Proposed Change to Technical Specifications:  
Densification Analyses and Related Technical  
Specifications Changes for Type 5 and Type  
6 Fuel

PLANT NAME: Nine Mile Point Unit #1

Re: Nine Mile Point Unit 1  
AEC Docket No. 50-220

## II. Proposed Changes to Technical Specifications

FIGURE 3.1.7. e MAXIMUM ALLOWABLE AVERAGE PLANAR LHGR  
APPLICABLE TO FUEL TYPE 5 and 6

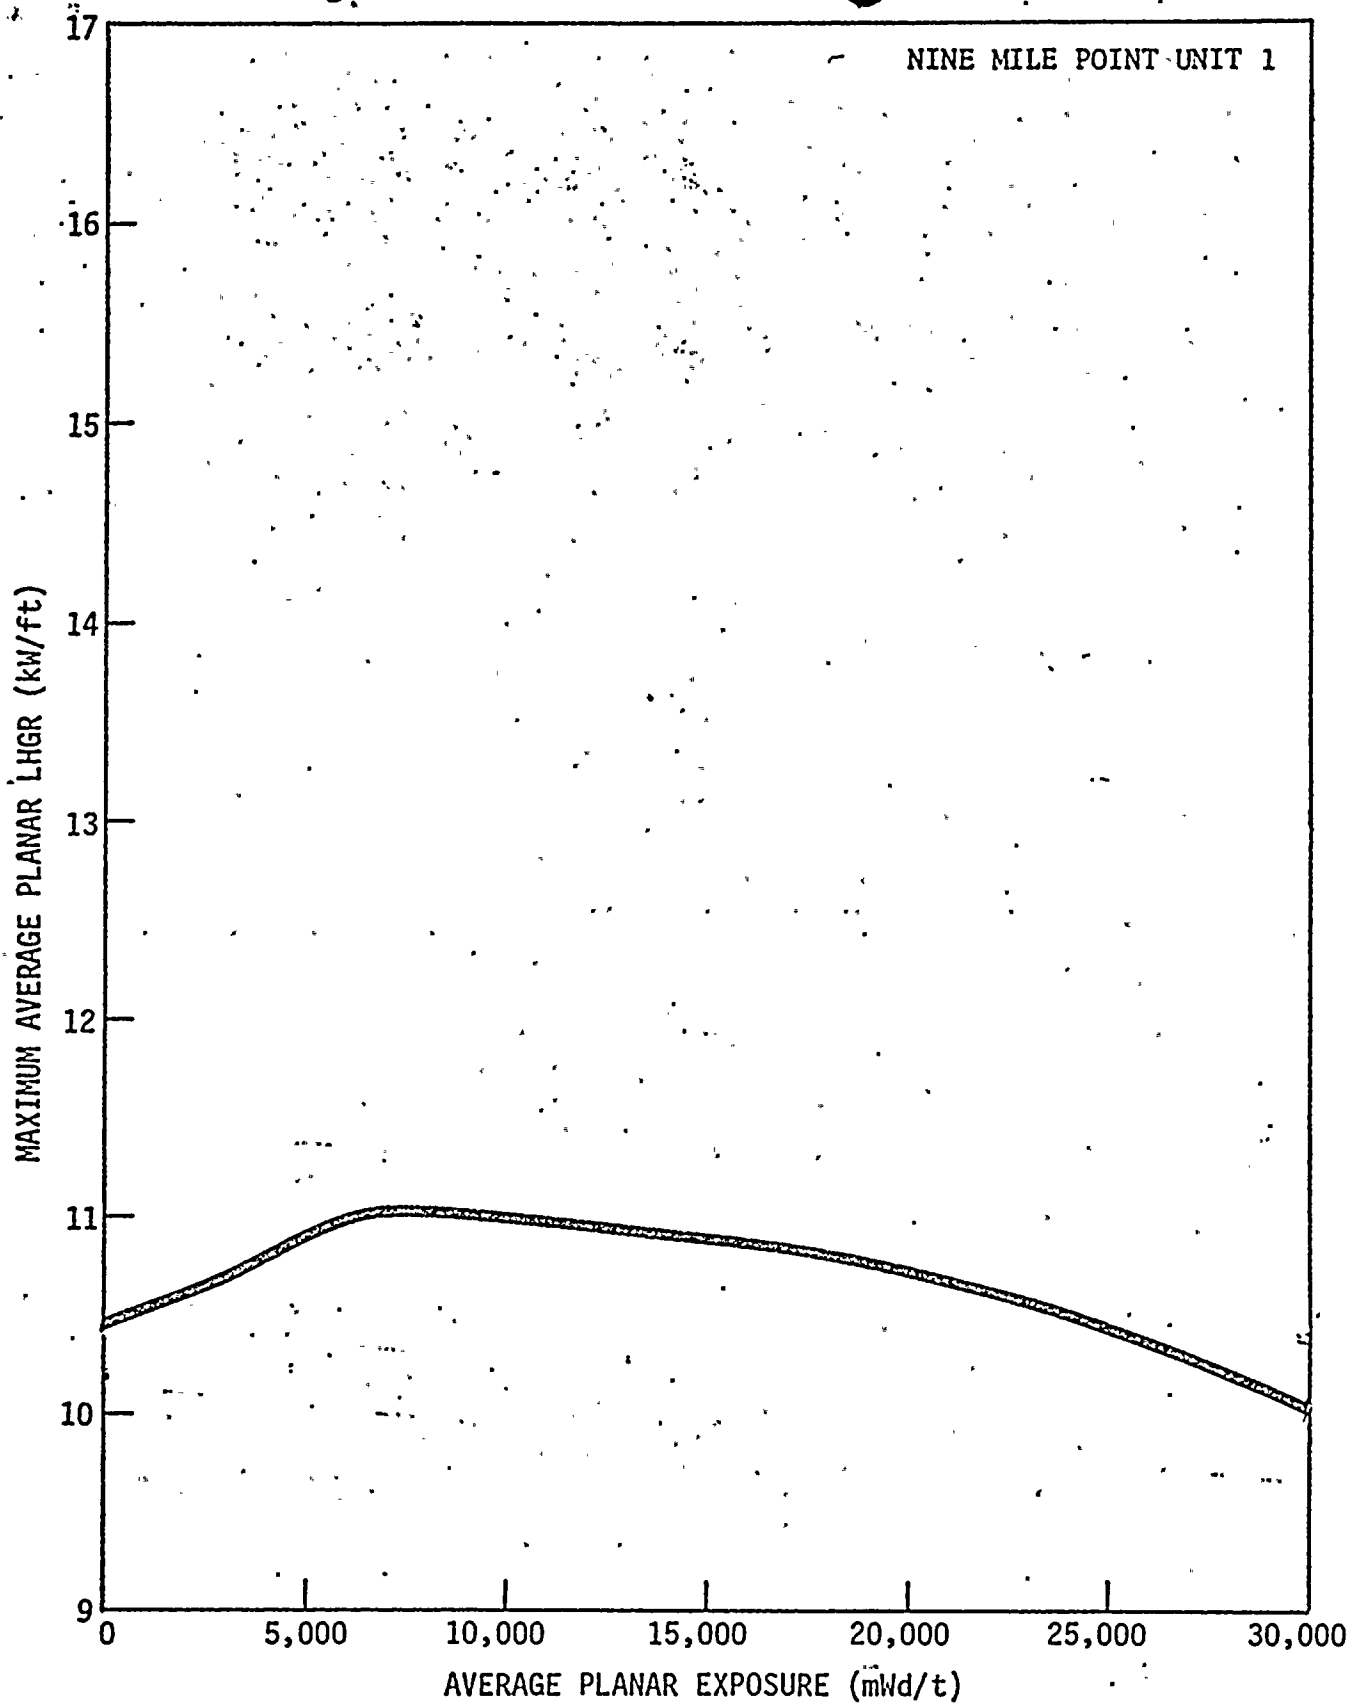
Add the attached Figure 3.1.7e to the Technical Specification. Under the Limiting Condition for Operation 3.1.7, add Figure 3.1.7e to the list of figures at the end of the last sentence in paragraph a.

Add Figure 3.1.7e to the list of figures in the third paragraph of the Bases 3.1.7a.

The results of analyses performed for 8x8 reload fuel has indicated that limits on MAPLHGR and power spiking penalties due to densification are required. These limits as they apply to Type 5 and Type 6 fuel are presented for incorporation into Nine Mile Point Unit 1 Technical Specifications.
